ADDENDUM NO. 2 COVER SHEET

PROJECT: DOWNTOWN STREETScape, PHASE 5

ADDENDUM NO. 2
for
DOWNTOWN STREETScape, PHASE 5

ALTERNATE 5:

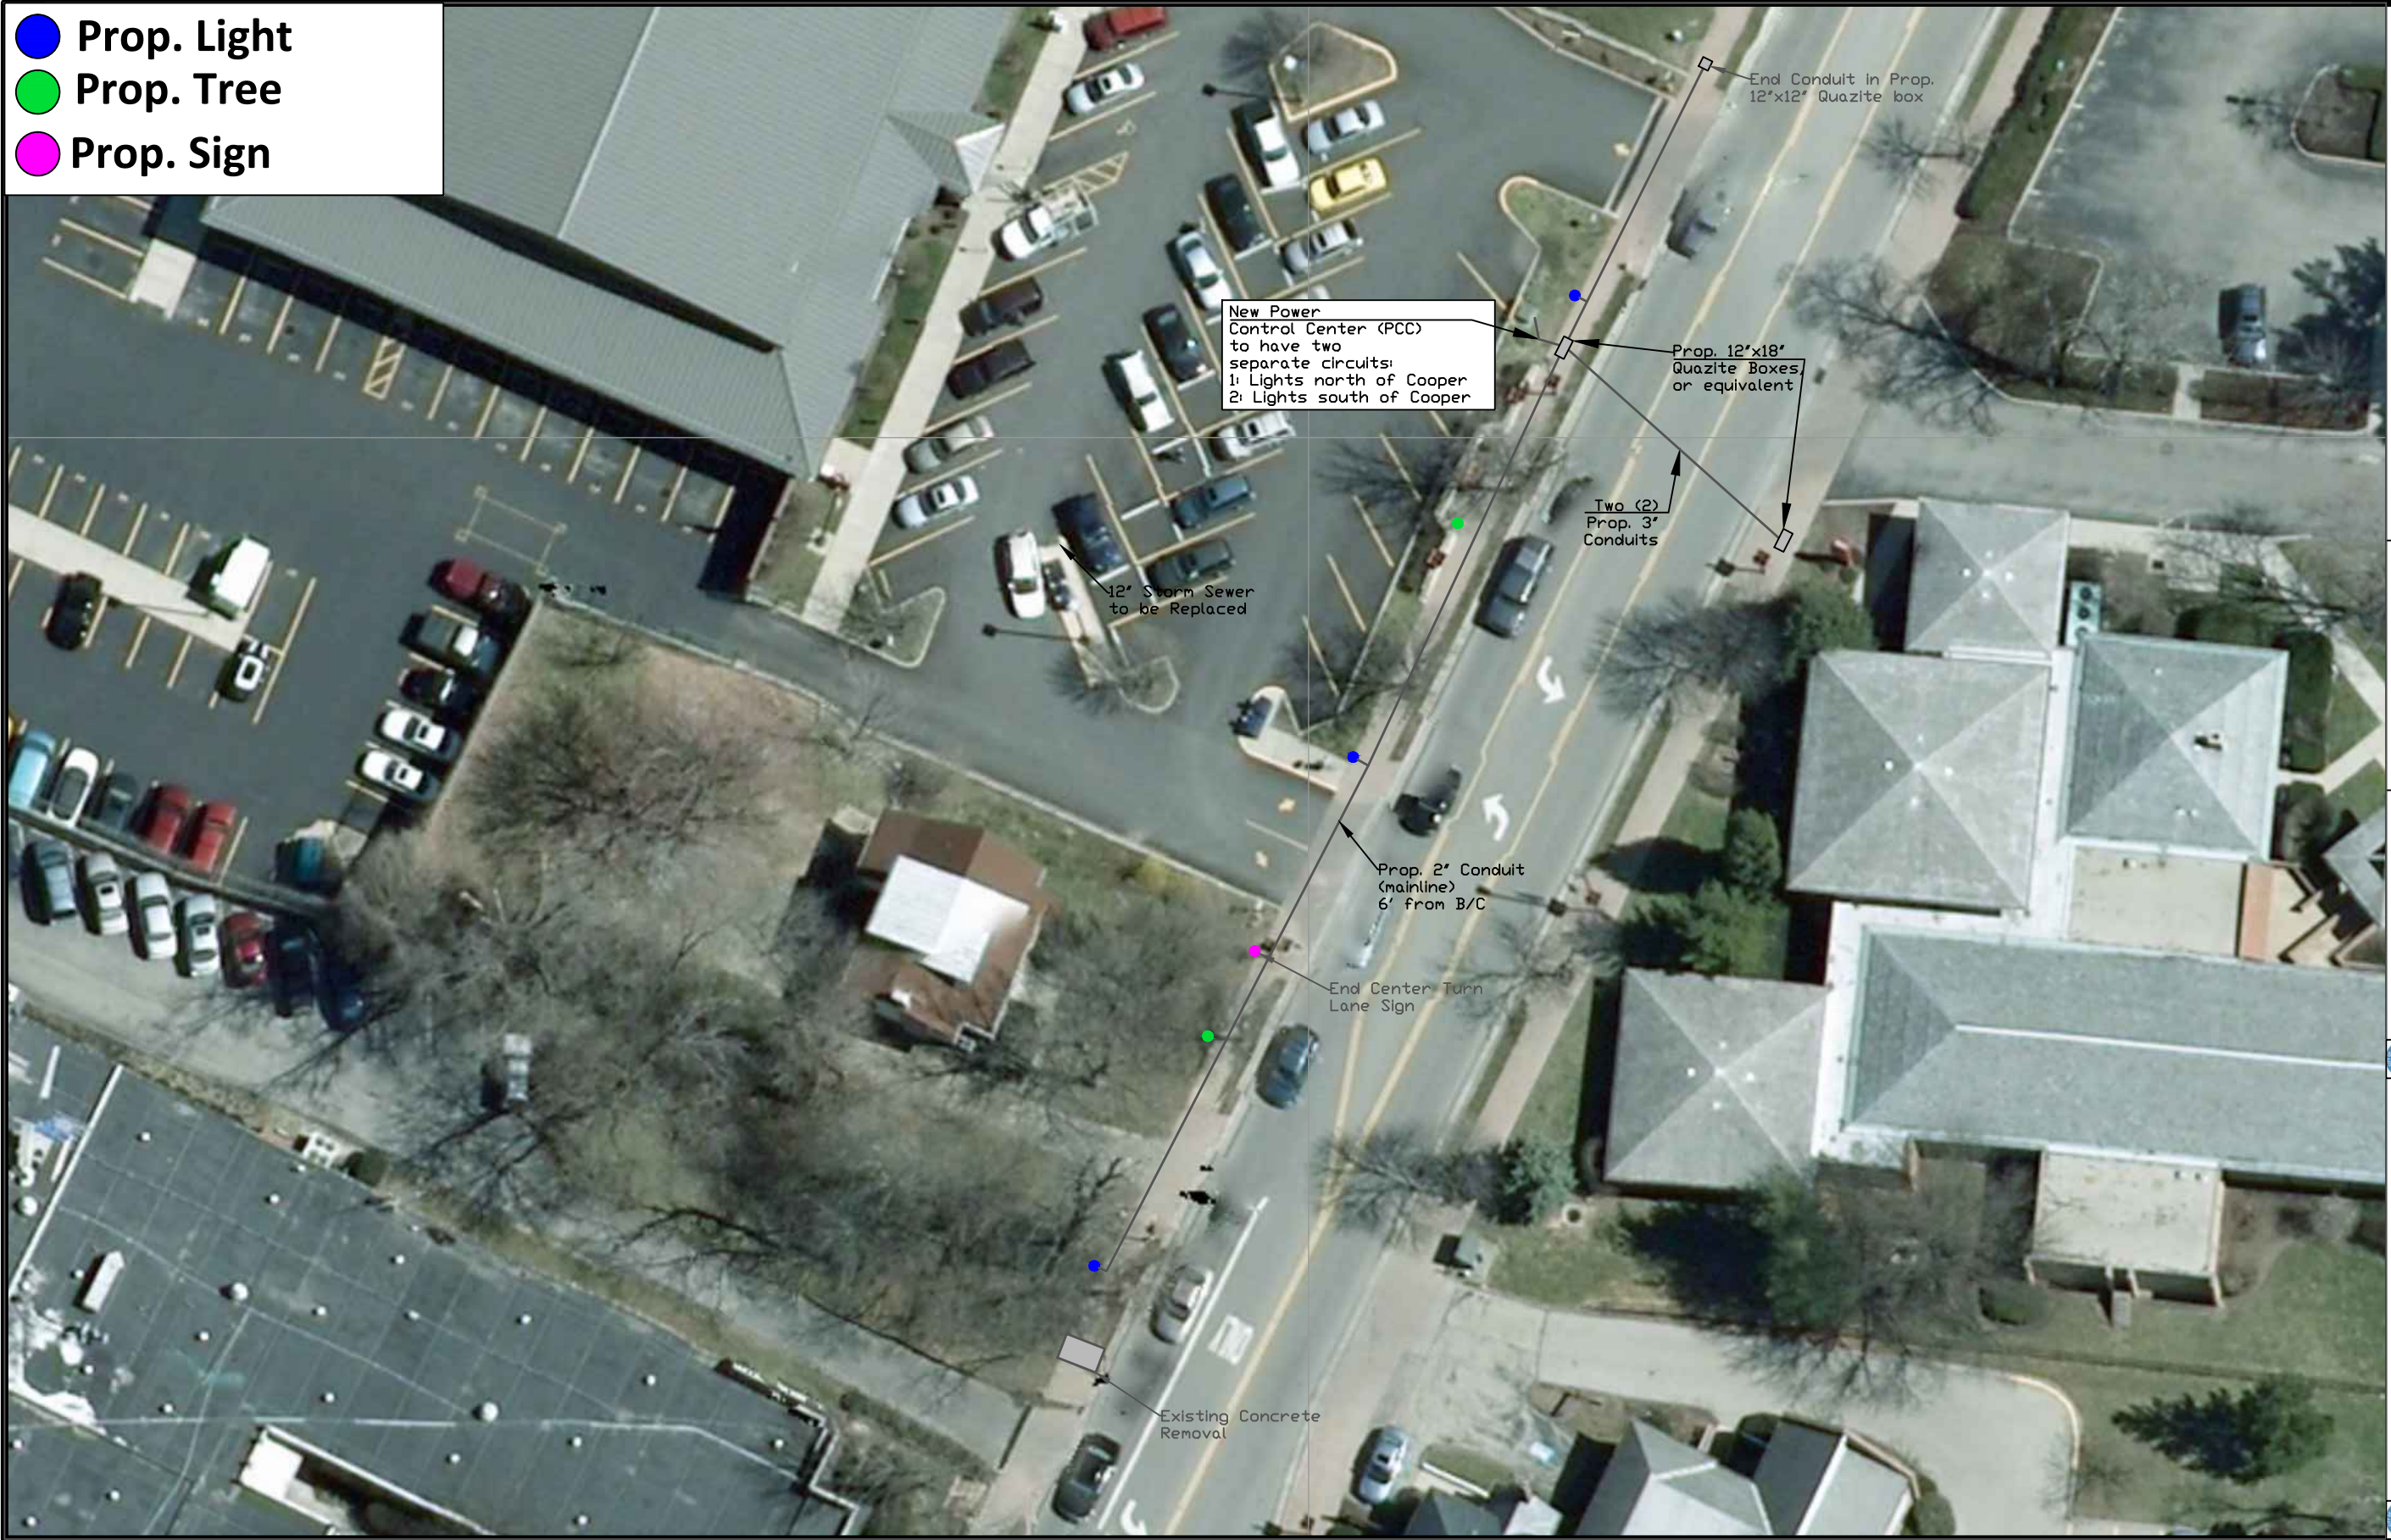
1. This is a new alternate and unrelated to the clarification made above.
2. This work will consist of replacing approximately 215' of a failed 12" pipe. The pipe has been patched together over the years and is a mismatch of several types of pipes. There will also be downspouts to tie in.
3. The gas service for 4906 Cooper Rd is bored through the pipe. Contractor is expected to coordinate with Duke. Cost for this shall be incidental to the 12" pipe cost.
4. In addition to the pipe replacement there will be sidewalk, lights, silva cells, and trees installed as shown on the attached plan. The wall at the post office shall also be removed.
5. Use the new bid tab provided. No changes except for the Addition of Alt 5 have been made.

CITY OF BLUE ASH
 PUBLIC WORKS DEPARTMENT
PROPOSED INFRASTRUCTURE

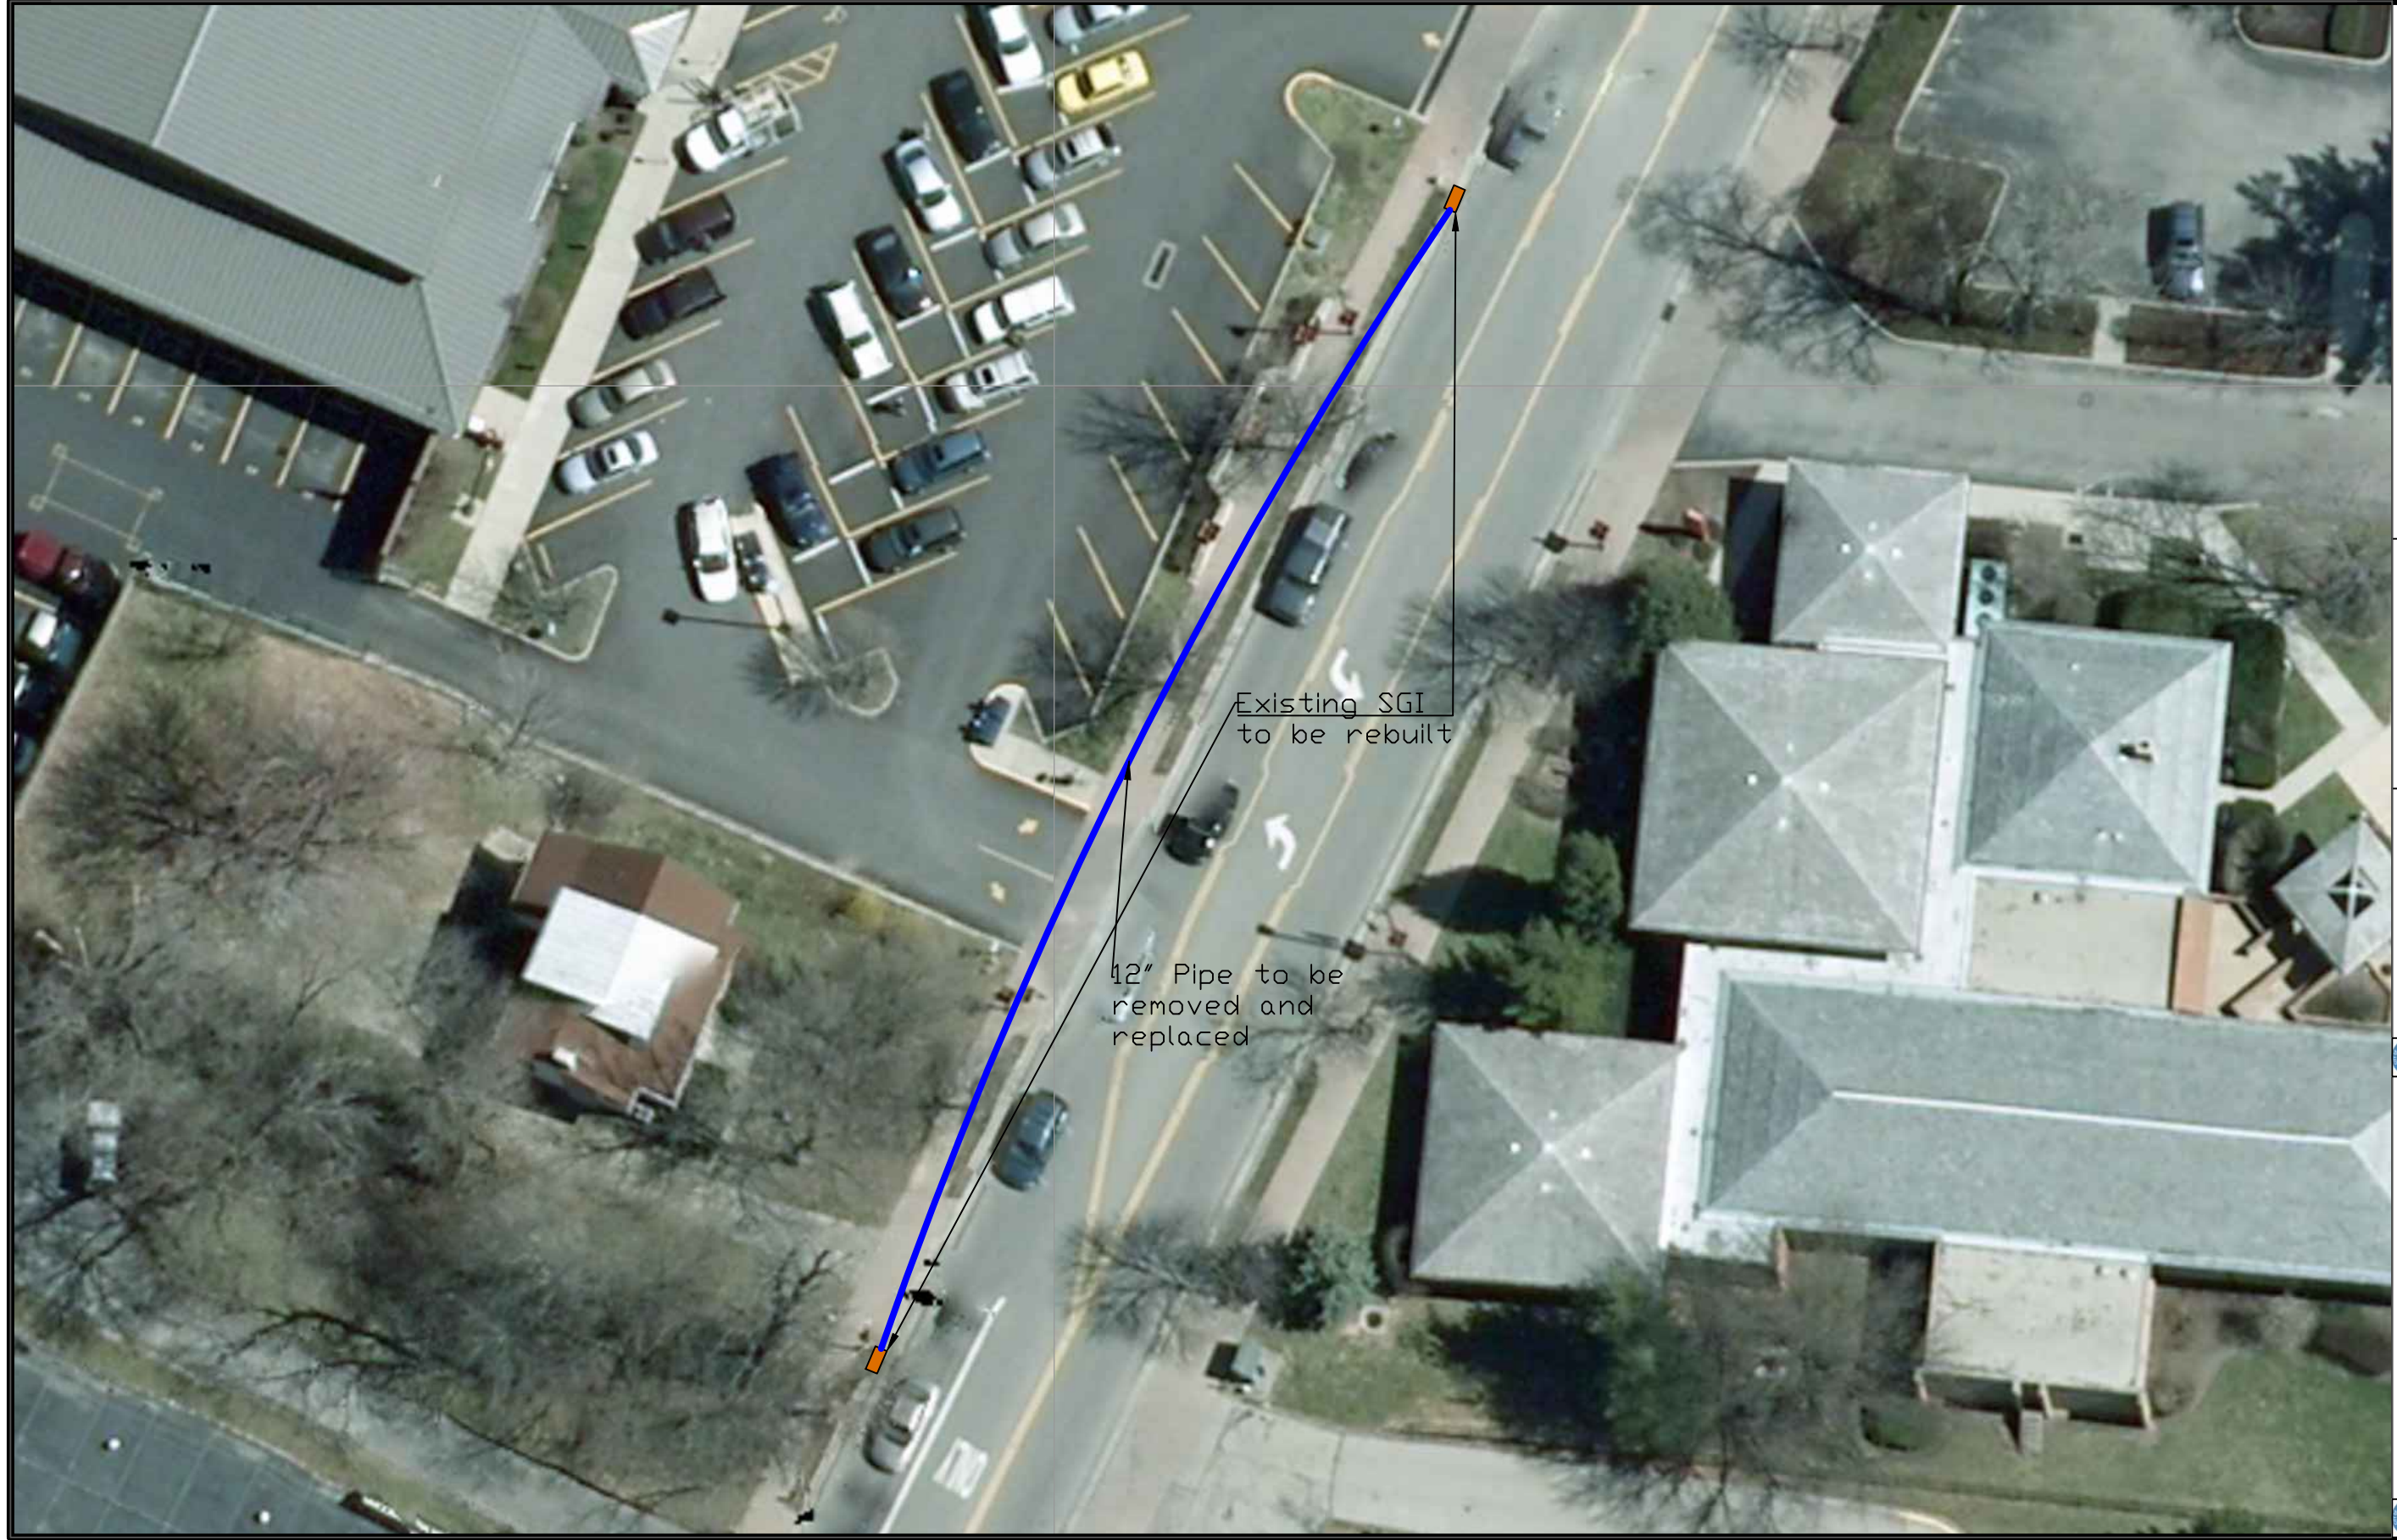
1. The City will provide an assembled power control system similar to what's been installed near Qdoba on Kenwood Rd. The Contractor will need to run conduit and wire to the station, wire it up, and then run conduit and wire to within 2' of the existing transformers. Conduit and wire shall be paid from their respective line items.
2. References to "Alternate 5" on the plan pages should be ignored. This is a remnant that should have been deleted.
3. Light poles shall be installed into an orientation that has the hand holes facing away from the street.
4. All catch basins shall be torn completely out and rebuilt from precast catch basin sections. Floors may remain if in good shape.

CLEAN-OUT AND TIE IN DETAIL

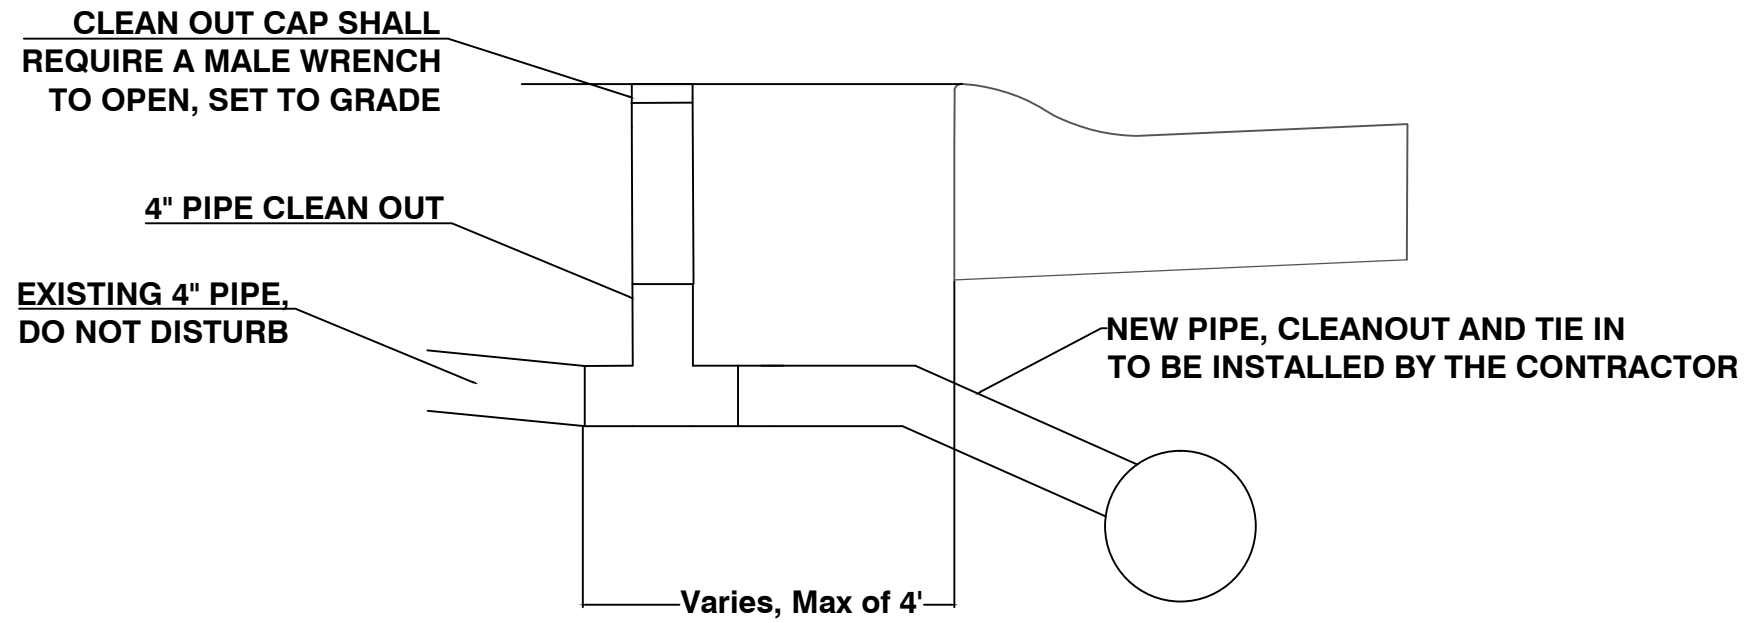
ALL BENDS SHALL BE SWEEPS
